**STAFF REPORT**

SUBJECT: H-2022-0028  
 Slim Chickens – CUP

LOCATION: 3369 W. Chinden Blvd. in the NE 1/4 of Section 27, T.4N., R.1W. (Lot 7, Block 1, Lost Rapids Subdivision)

LANDSCAPE PLAN

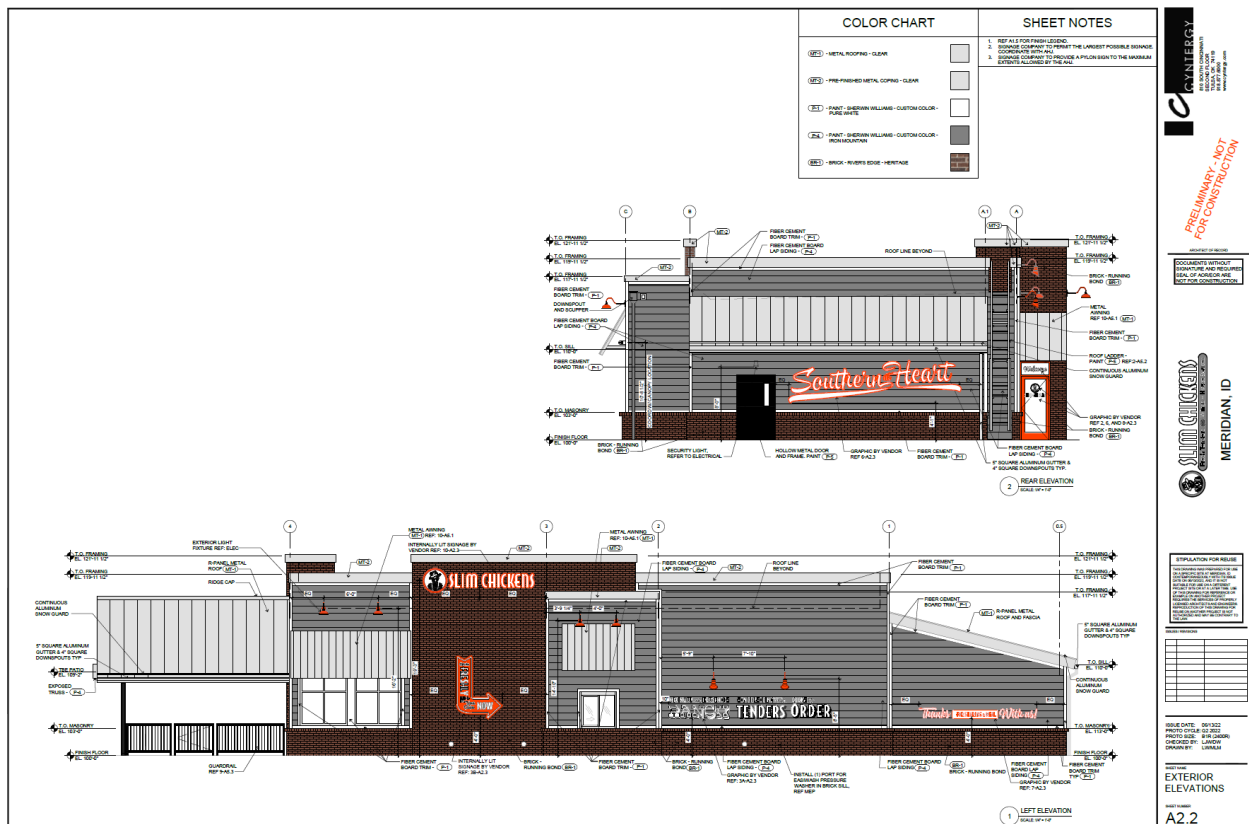
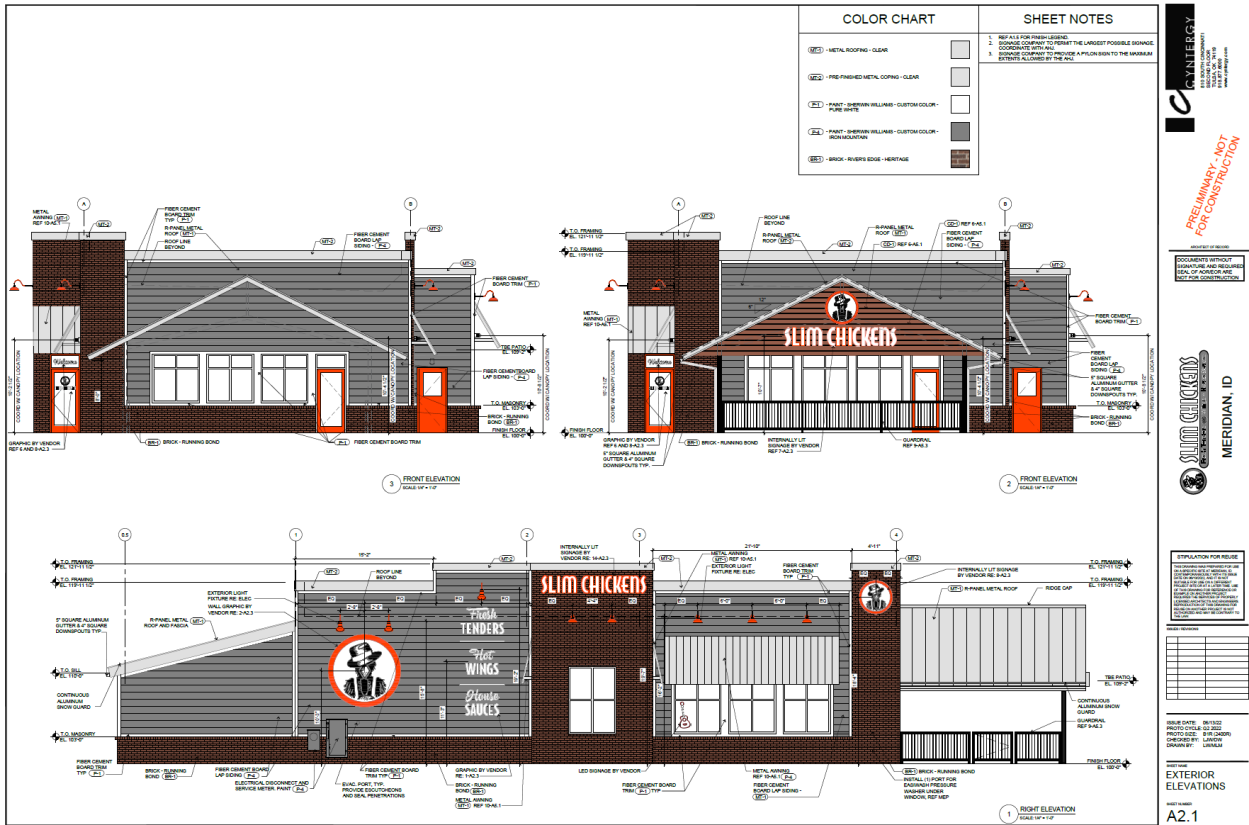
**Staff is concerned the two (2) northern parking spaces on the east side of the site adjacent to the drive-through on this site may present traffic conflicts between vehicles exiting the drive-through on the adjacent property to the east and vehicles trying to park or exit those parking spaces; therefore, Staff recommends either restricting those spaces to employee parking only, signed accordingly, or removing those spaces.**

Parking lot landscaping is required to be provided in accord with the standards listed in UDC [11-3B-8C](#). **At a minimum, all perimeter buffers are required to be 5-foot wide (measured inside curbs) and planted with one (1) Class II or III tree per 35 linear feet and shrubs, lawn or other vegetative groundcover, per UDC 11-3B-8C.1b (the northern portion of the buffer along the west boundary appears to be narrower than 5 feet and doesn't comply with the landscaping standards). Interior planters that serve a single row of parking spaces are required to be landscaped with at least one (1) tree and shall be covered with low shrubs, lawn, or other vegetative groundcover, per UDC 11-3B-8C.2d. The buffer along the south boundary of the site and along the east side of the drive-through should be widened to a minimum of 7 feet to allow for 2 feet of vehicle overhang in accord with UDC 11-3C-5B.4 – parking stalls may be reduced to 17 feet in length; or, wheel stops may be provided in parking spaces to prevent vehicle overhang. The landscape plan submitted with the Certificate of Zoning Compliance application should be revised to reflect compliance with these standards.**

- e. Depict landscaping in the perimeter buffer and within the parking area in accord with the standards listed in UDC [11-3B-8C](#).
  - f. Remove the northern two (2) parking spaces on the east side of the site adjacent to the drive-through on this site so that vehicles aren't backing out into drive-through lane on the adjacent site to the east; or, restrict those spaces to employee parking only, signed accordingly.

- g. Widen the perimeter buffer along the south boundary of the site and along the east side of the drive-through to 7 feet to allow 2 feet of vehicle overhang (parking stalls may be decreased to 17 feet in length); or, provide wheel stops in parking spaces to prevent vehicle overhang, as set forth in UDC 11-3C-5B.4.

- h. Widen the northern portion of the perimeter buffer along the west boundary to a minimum of five feet (5') and depict landscaping per the standards listed in UDC [11-3B-8C.1](#).
